SUBJECT: FAU 6713 (Camp Street)
Section 19-00171-00-RP (East Peoria)
Tazewell County
Contract No. 89818
Item 169
March 7, 2025 Letting
Addendum (A)

NOTICE TO PROSPECTIVE BIDDERS:

Attached is an addendum to the plans or proposal. This addendum involves revised and/or added material.

Figure 4-1 Sheet 1 of 2
669.05 Soil Classification Map
Camp St. and Riverside Dr.
Reconstruction Project PSI
East Peoria, Tazewell County, IL

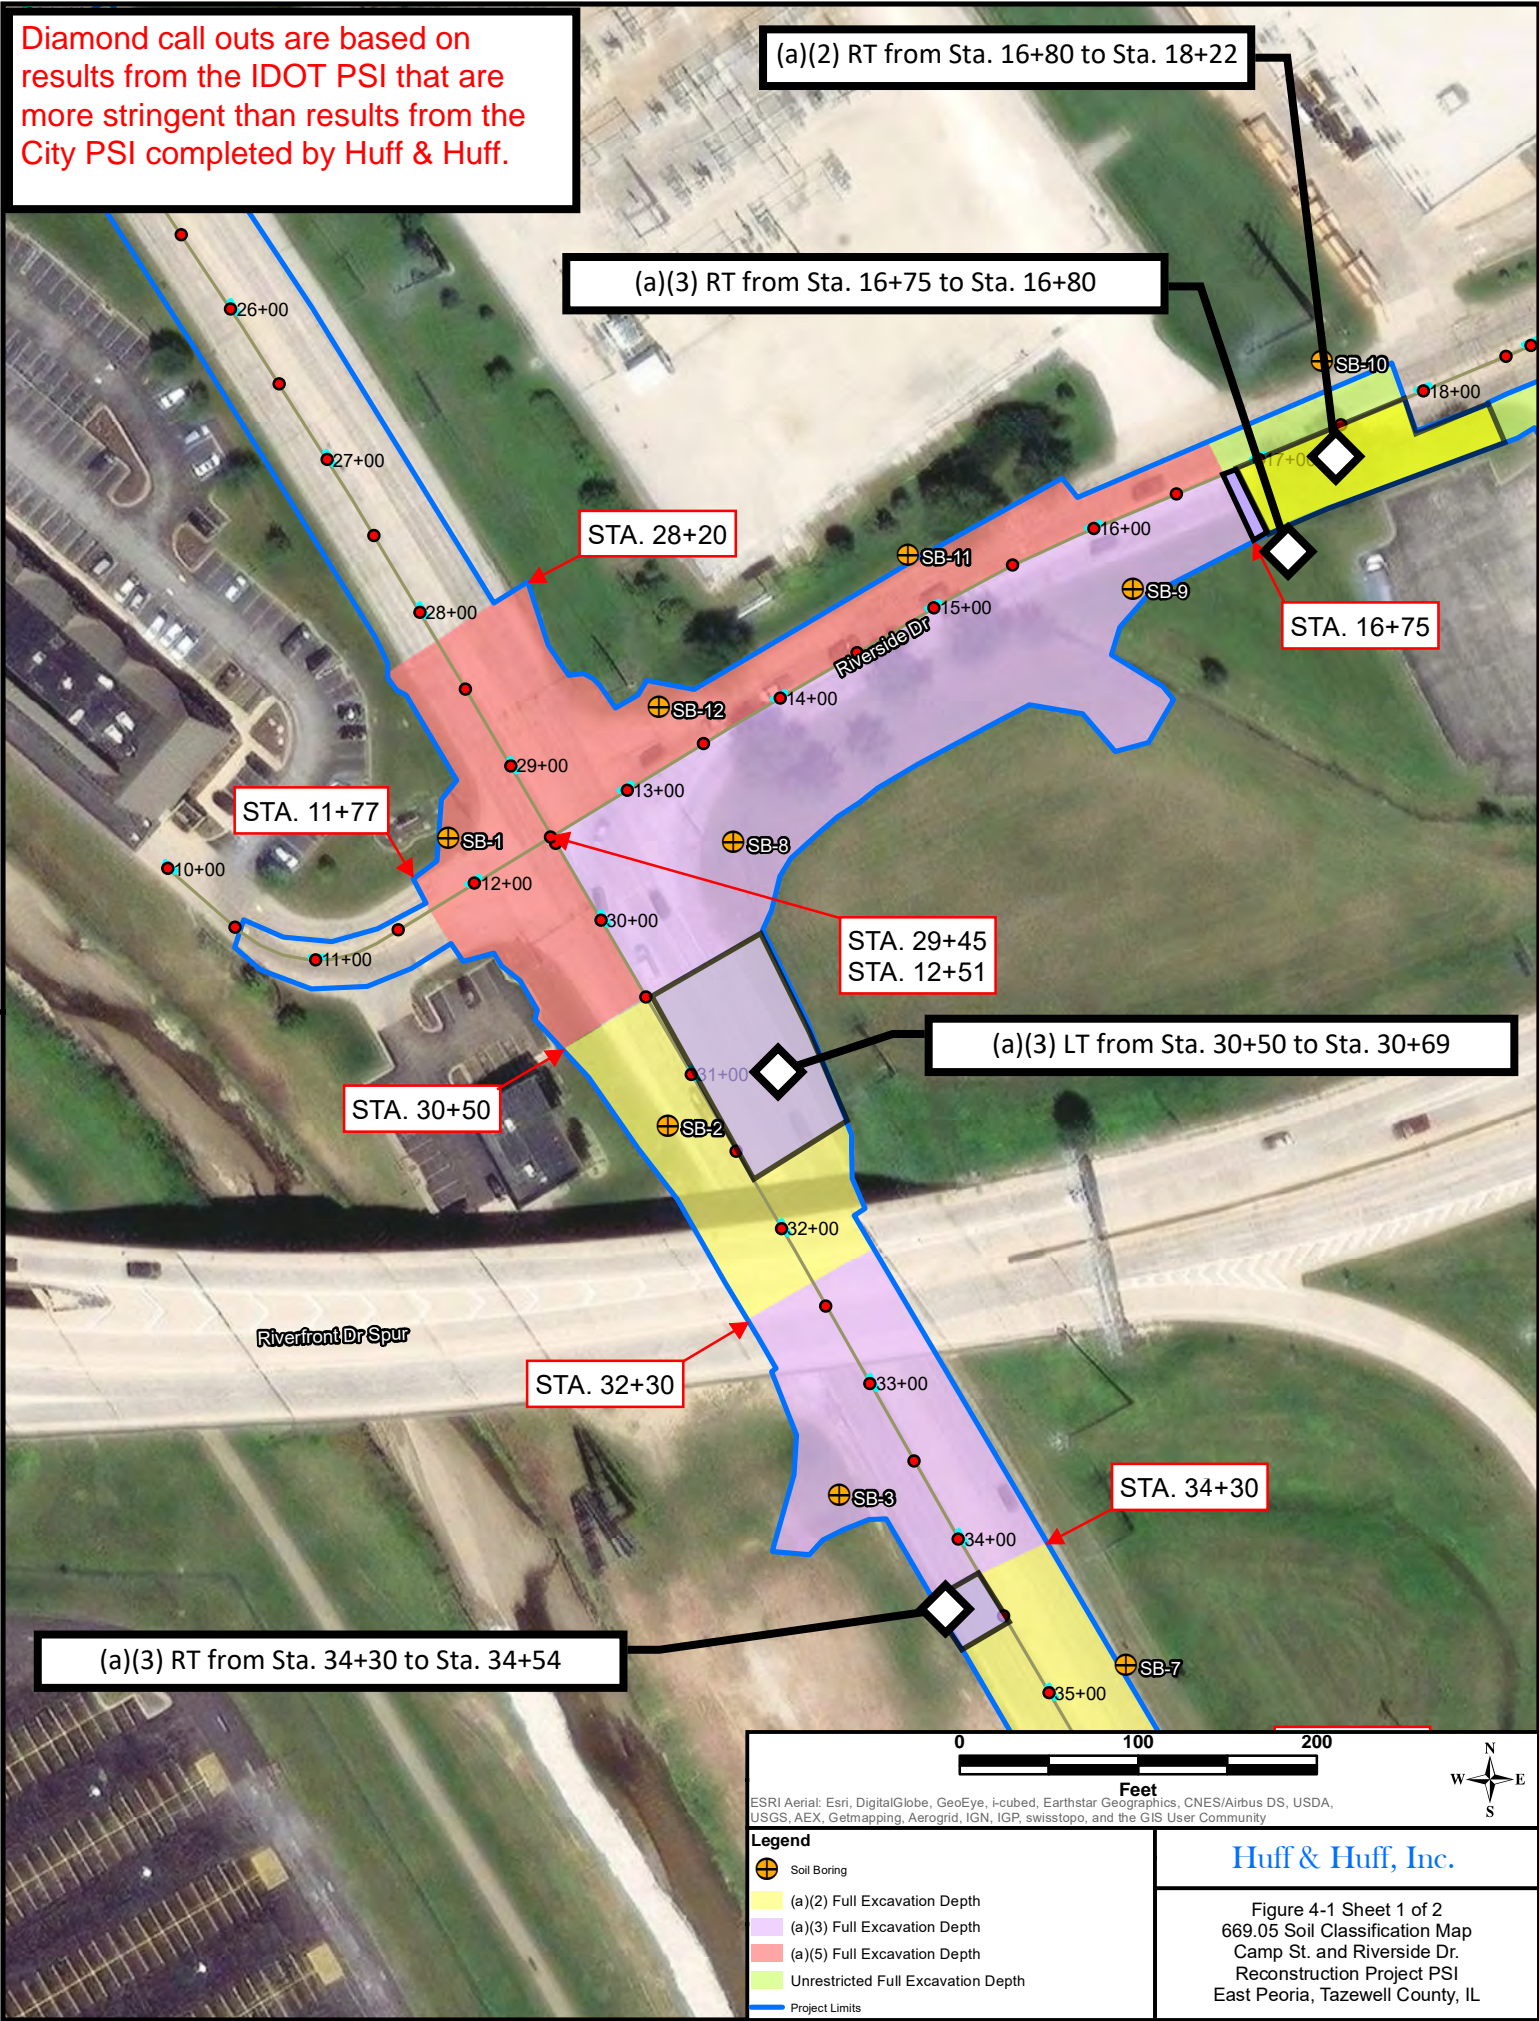
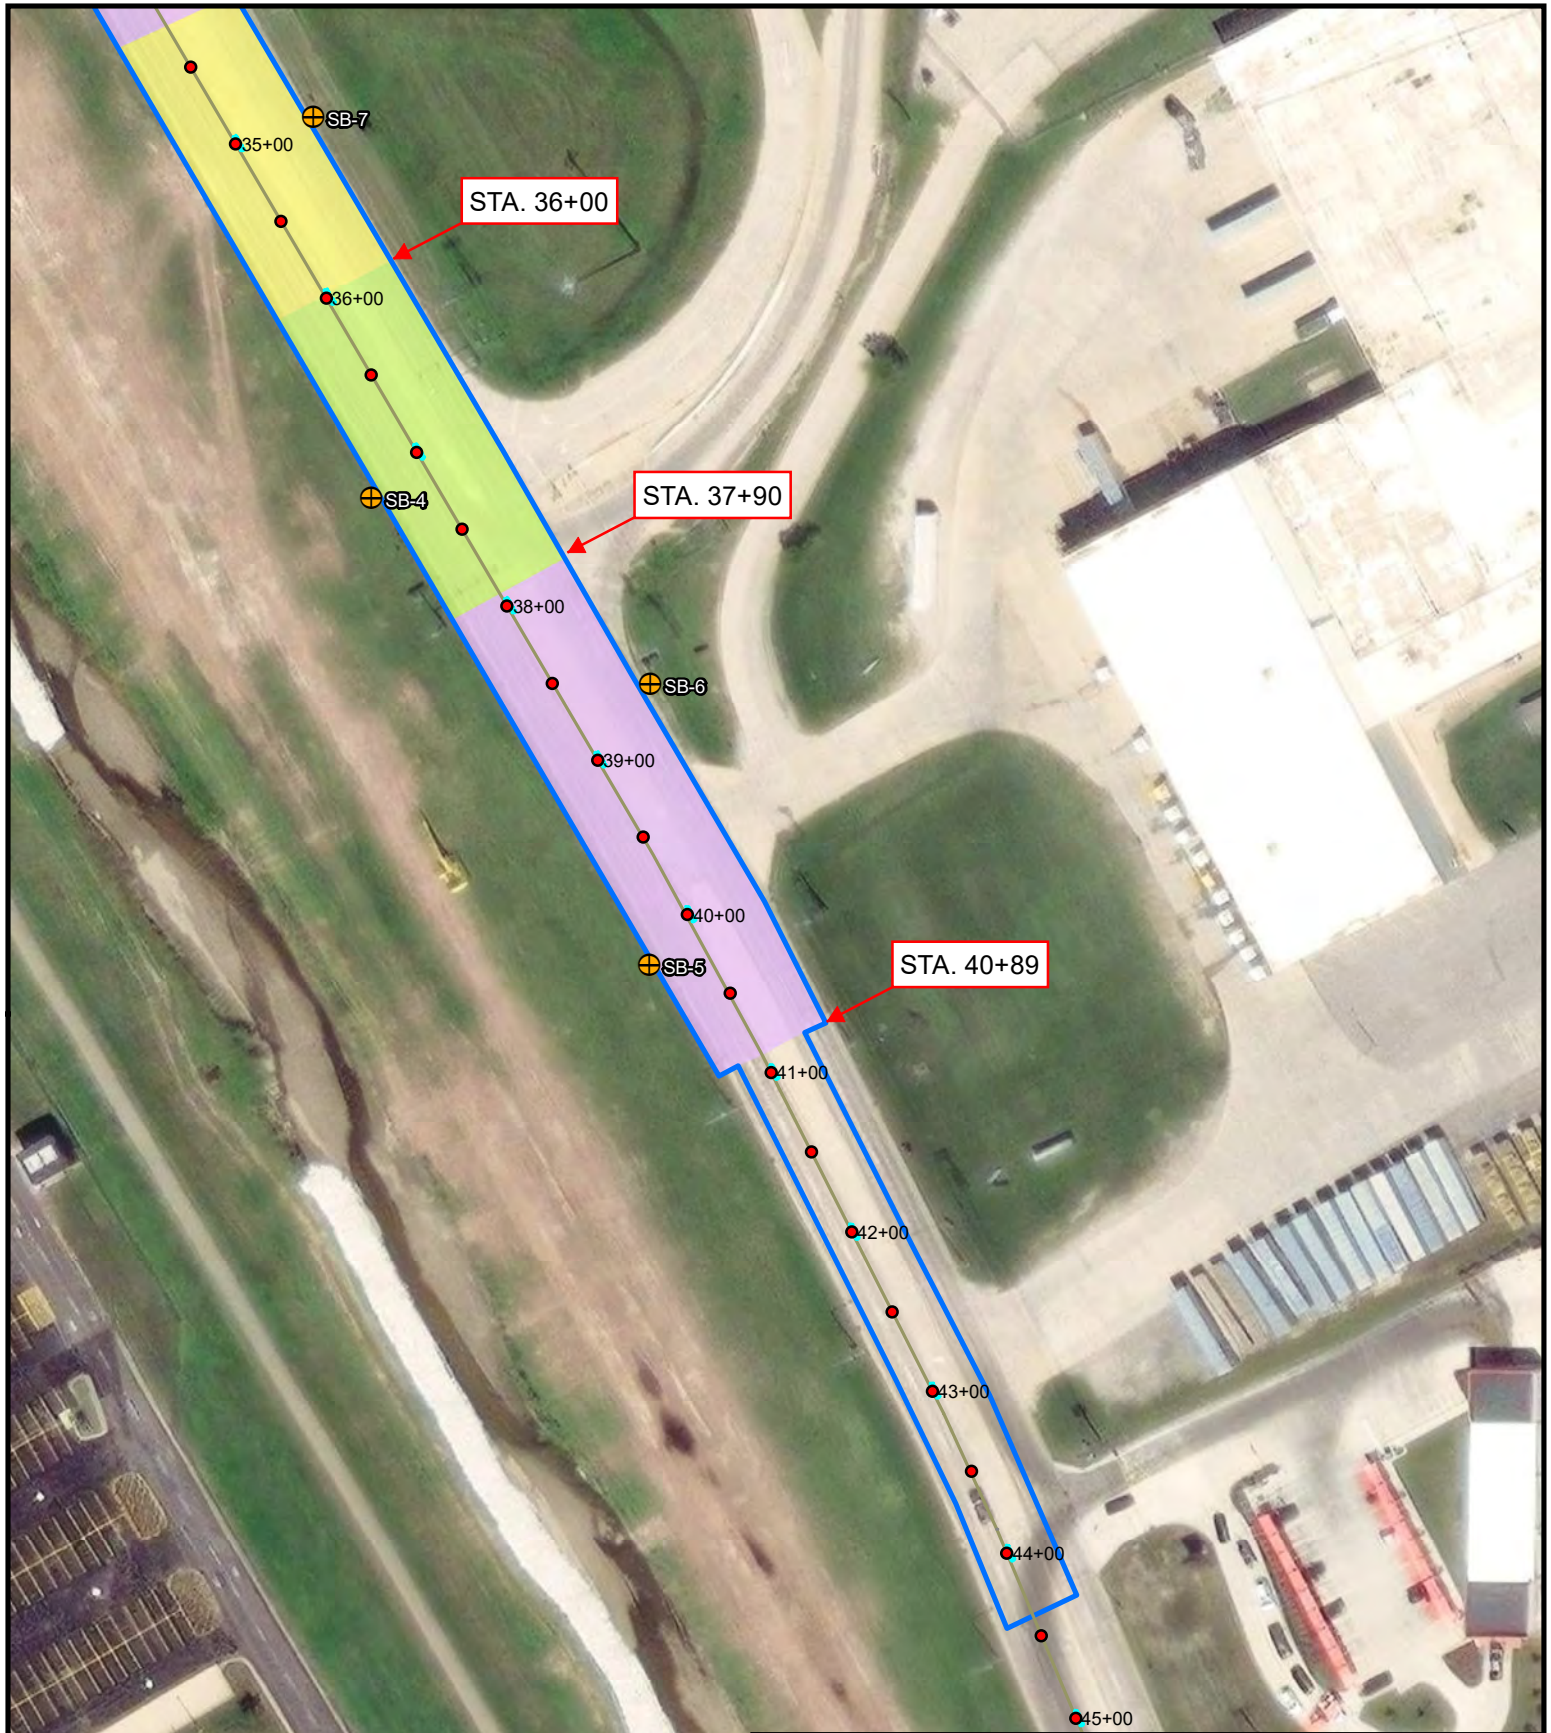
Diamond call outs are based on results from the IDOT PSI that are more stringent than results from the City PSI completed by Huff & Huff.
